**WHEELING PLAN COMMISSION
THURSDAY, FEBRUARY 22, 2018 6:30 P.M.**

REQUEST FOR PLAN COMMISSION ACTION
STAFF PROJECT REVIEW

RE: Docket Nos. 2017-18 and SCBA 18-4
Shri Swaminarayan Temple
397 Northgate Parkway
(2017-18) Special Use-Site Plan Amendment to Allow for a
Building Addition
(SCBA 18-4) Appearance Approval of a Freestanding Sign

MONUMENT SIGN LANDSCAPE PLAN

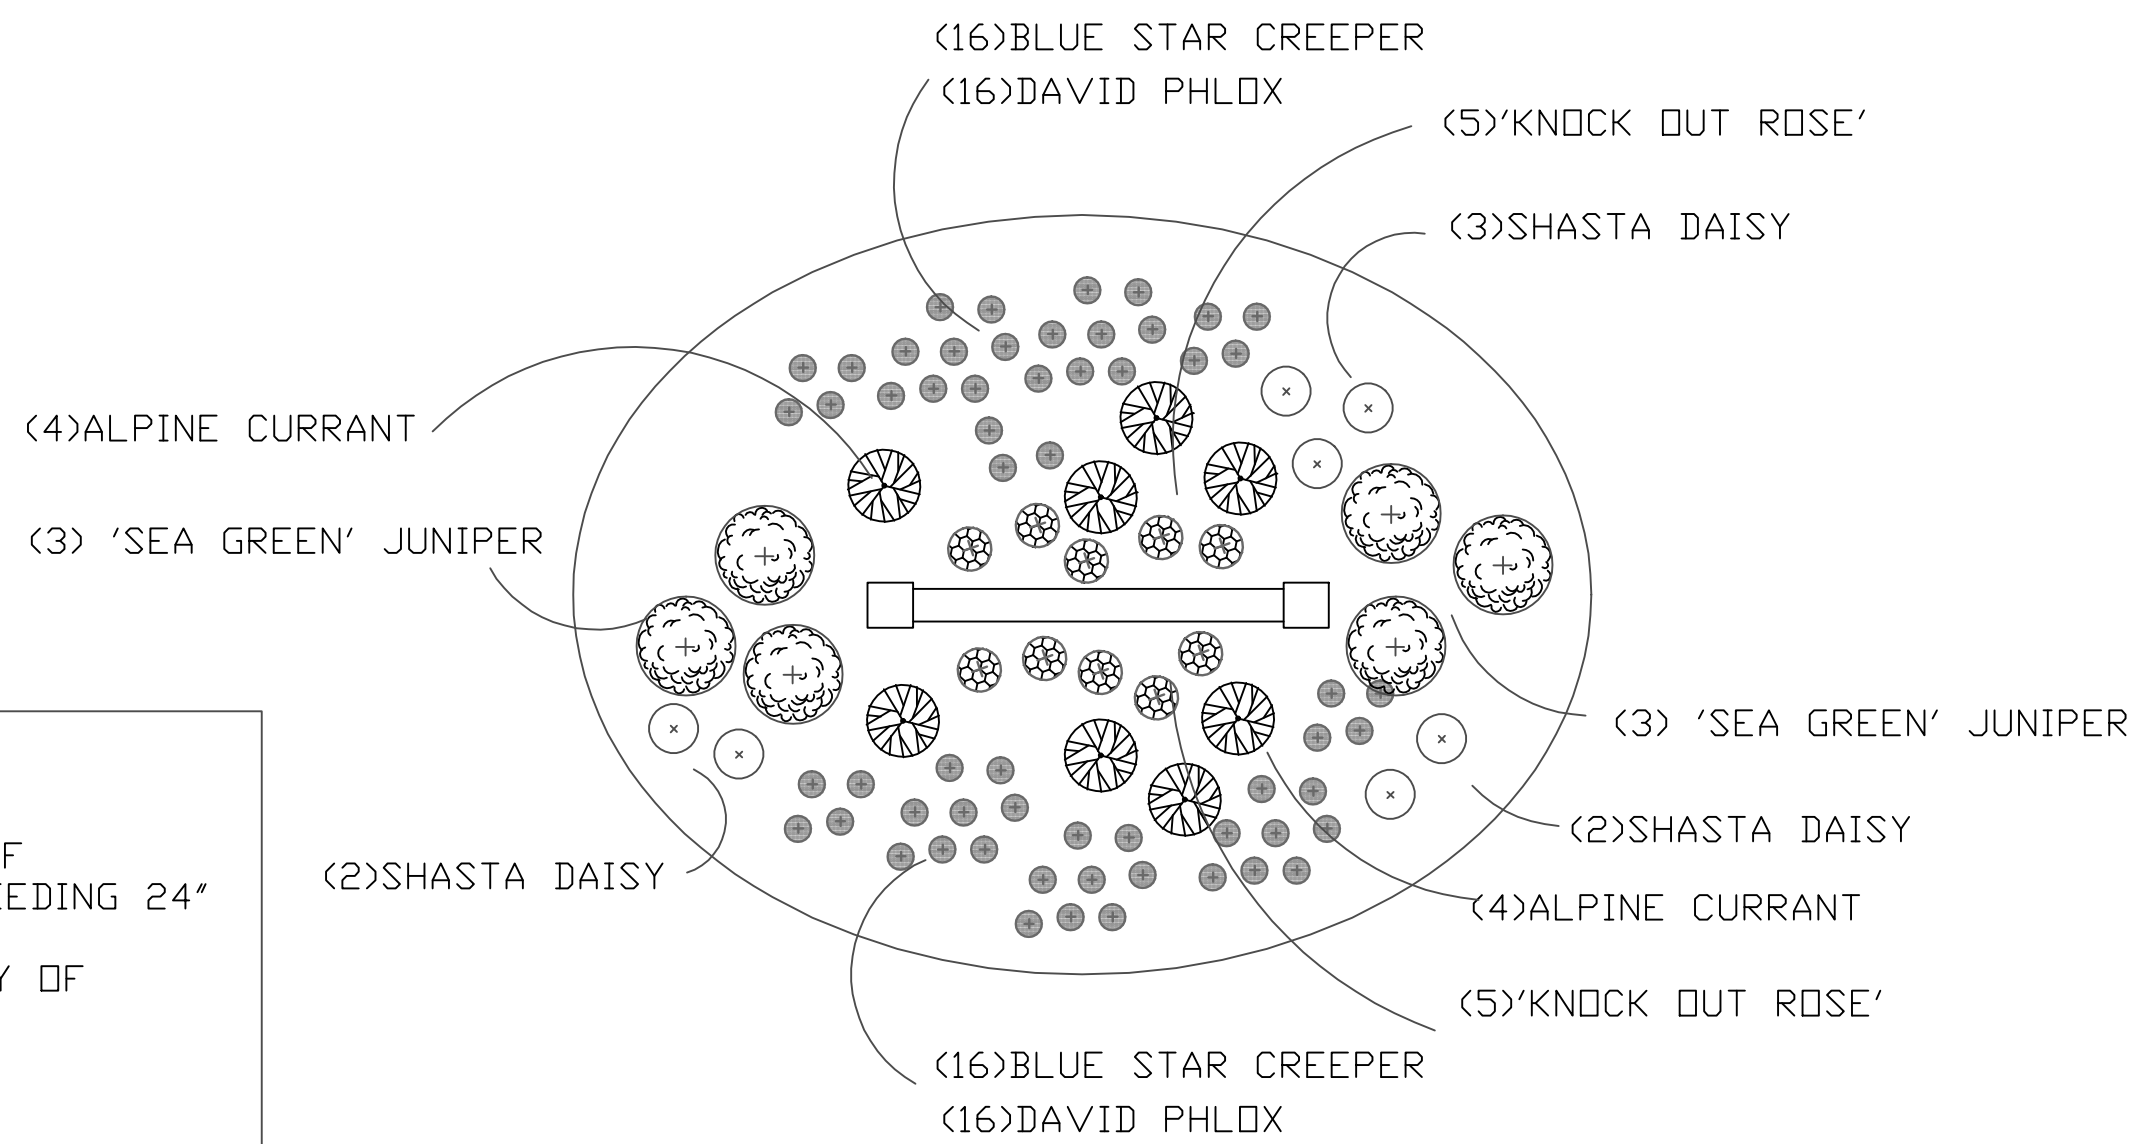
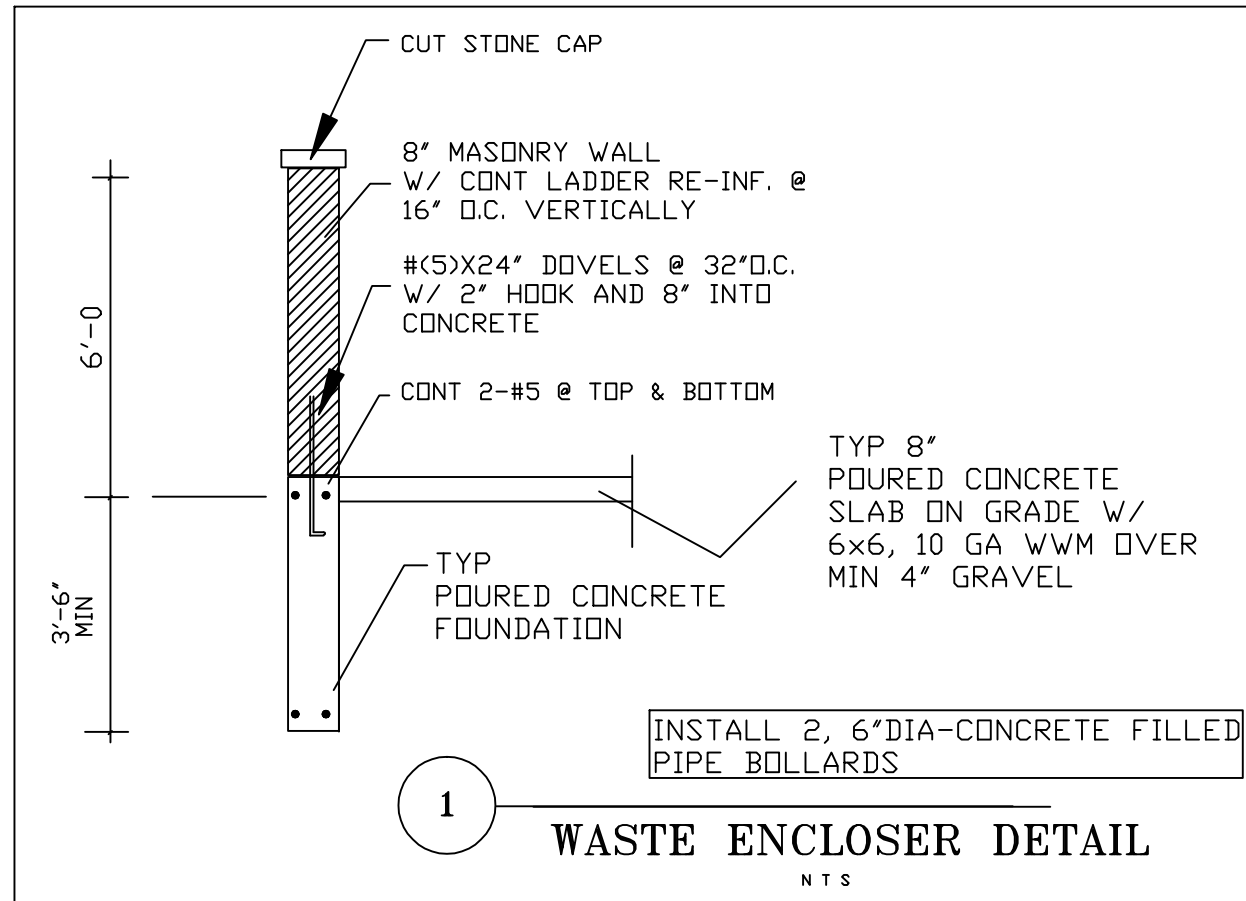
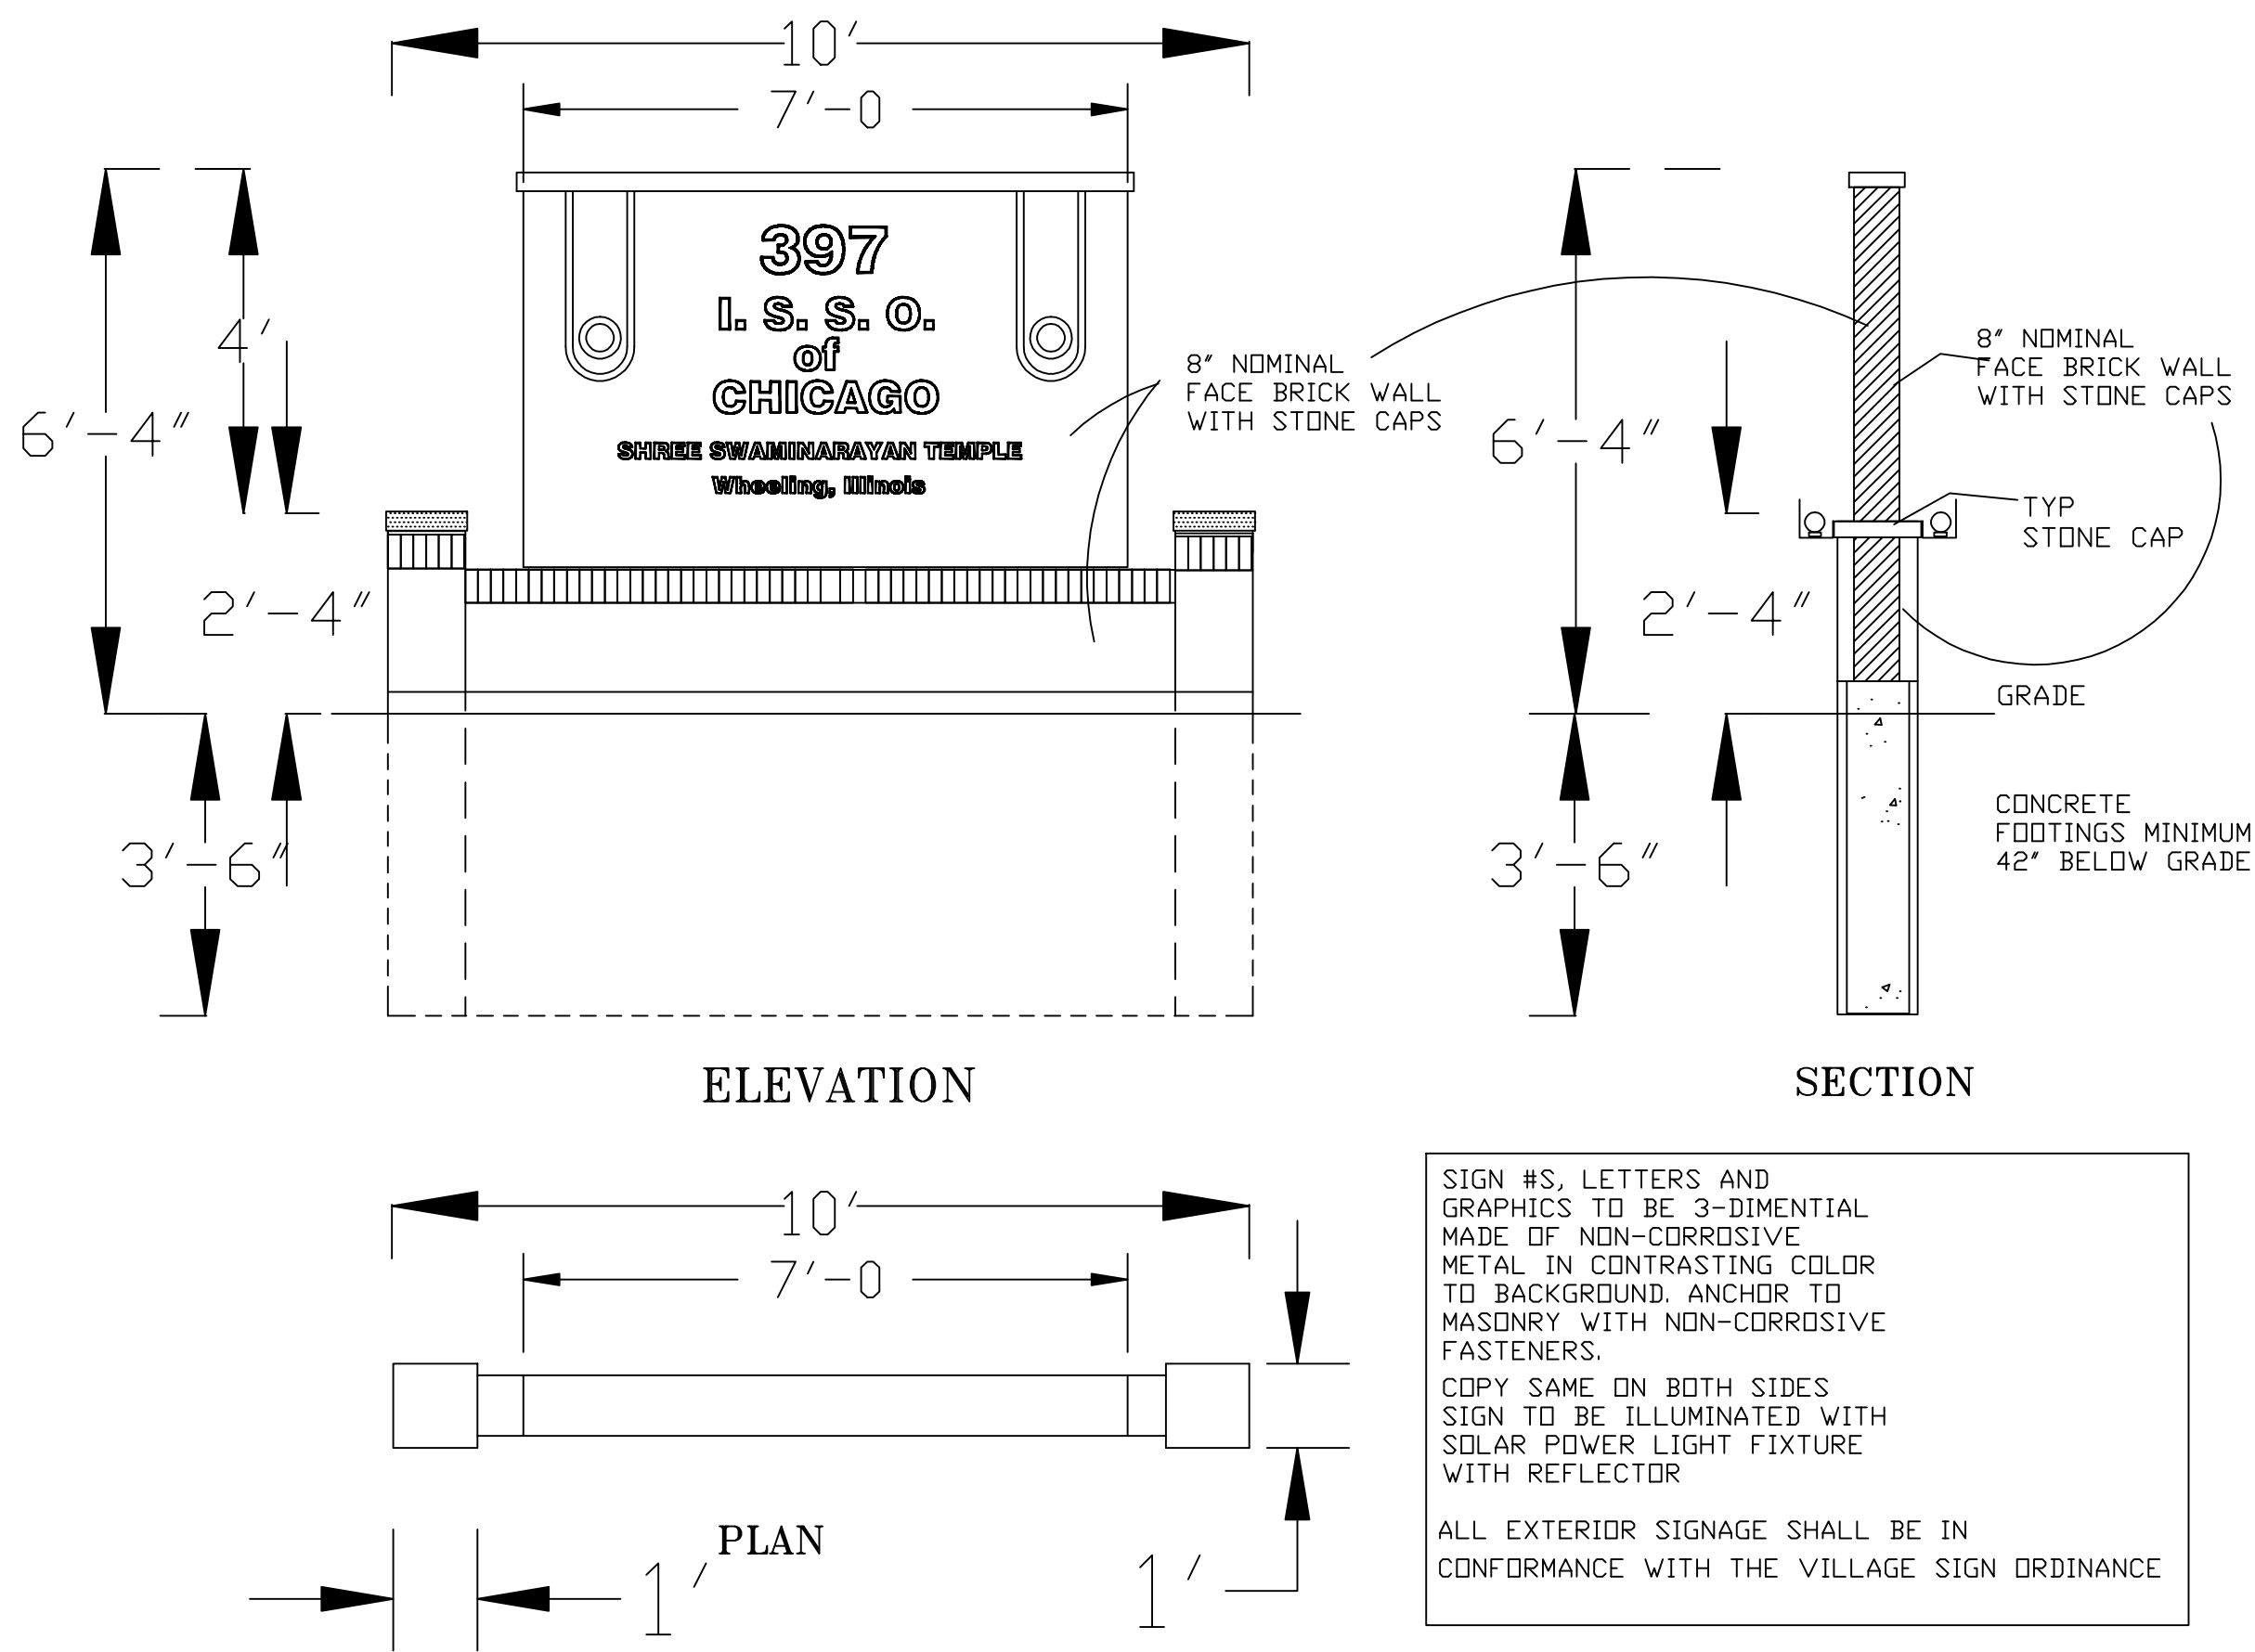
8. Spec sheets for building lighting and pole lighting to be provided. **Spec sheets have been provided.**
9. Provide a new sign plan showing the masonry material. **The sign plan has been revised to include an all brick structure.**

Sign Type, Materials and Size: The petitioner is proposing to install a monument-style freestanding sign. The sign will be double-sided and will include the name of the organization, the temple, and address in raised, non-corrosive metal letters. The sign will have an overall height of 6'4". Each sign face will have an area of 28 square feet. The sign will include a 2'4" masonry wall base with a stone cap. The structure will be externally illuminated with solar-powered fixtures. This sign meets the size requirements of the Sign Code. On January 25th, the Plan Commission asked that the plan be revised to show the requested masonry material of the sign face. The proposed material is face brick, which is the same as the base.

Landscaping: A landscape plan is proposed for the freestanding sign. The proposed landscaped area is approximately 240 square feet, which is over four times the size of the required landscaped area. The proposed landscape plan meets the species mix requirements of the Sign Code. It includes evergreens and winter interest (Sea Green Juniper), flowering perennials (Shasta Daisy, David Phlox, Knock Out Roses), deciduous shrubs (Alpine Currant), and groundcover (Blue Star Creeper). The landscape plan also notes that it will be irrigated.
